# Pre-Grid Punch List CFA 02258

Prepared by Will Turnbough

Jun 13, 2025

### #29 [DUCT 499] [EXIST] CRITICAL (MISC) - AC-4 existing duct

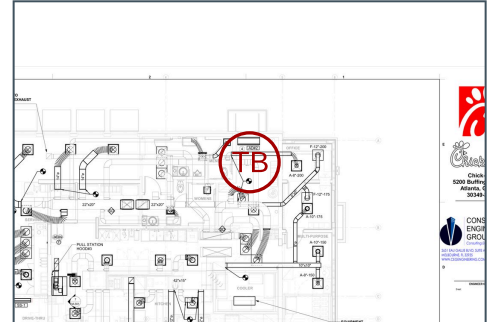
Duct run in back of the house has multiple issues. The duct run going to the office has an additional transition which will impact airflow. The takeoff that will serve that BOH area cannot be installed due to interference with another duct. The insulation is also damaged and missing from the end cap. Recommend this duct run be reinstalled.

### #28 [DUCT 017] [NEW] CRITICAL – Duct not installed per plans.

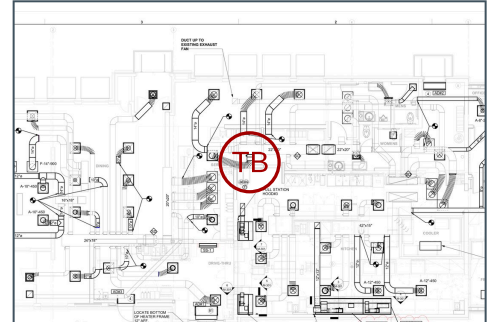
AC-2 is missing a takeoff that is shown on the plans.

## #27 [DUCT 498] [NEW] CRITICAL (DESIGN) - AC-2 return above ceiling

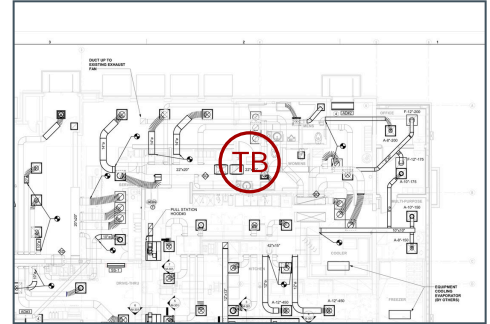
There is a return duct shown terminating above ceiling for AC-2 which is unusual for Chick-fil-A design. Consult engineer of record to ensure this is not an error and to confirm the purpose.

### #26 [DUCT 016] [NEW] CRITICAL – Duct is restricted – dimensional.

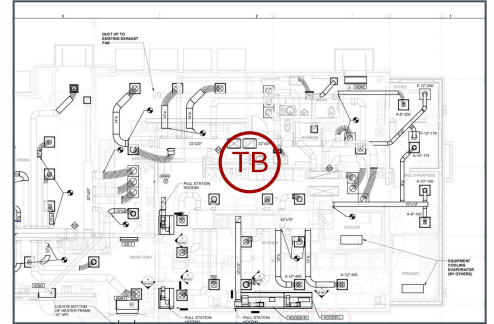
Duct on AC-2 serving the women's restroom is pinched as it is passing through the wall.

**#25 [DUCT 017] [NEW] CRITICAL – Duct not installed per plans.**

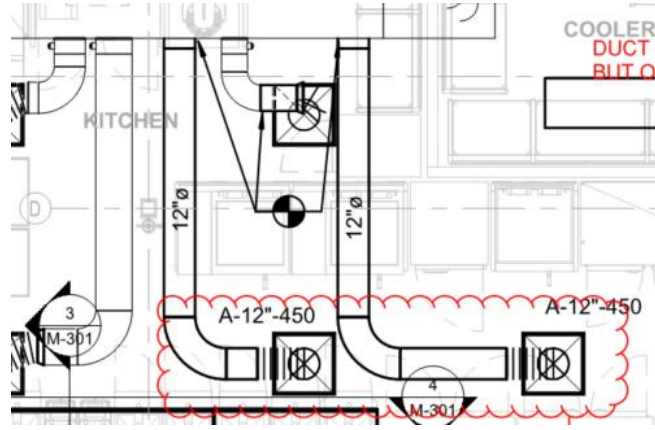
AC-1 has ducts that are not aligned as shown on the plan. Ensure they are ducted per plan so that the diffusers can be aligned in the grid without additional transitions in the duct.

**#24 [DUCT 017] [NEW] CRITICAL – Duct not installed per plans.**

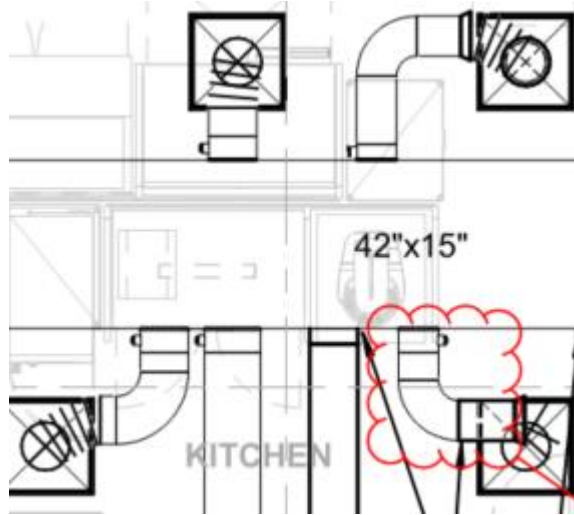
AC-1 has a takeoff that appears it can't be installed per design and will not allow for flex duct for vibration isolation. Consult engineer of record as required.
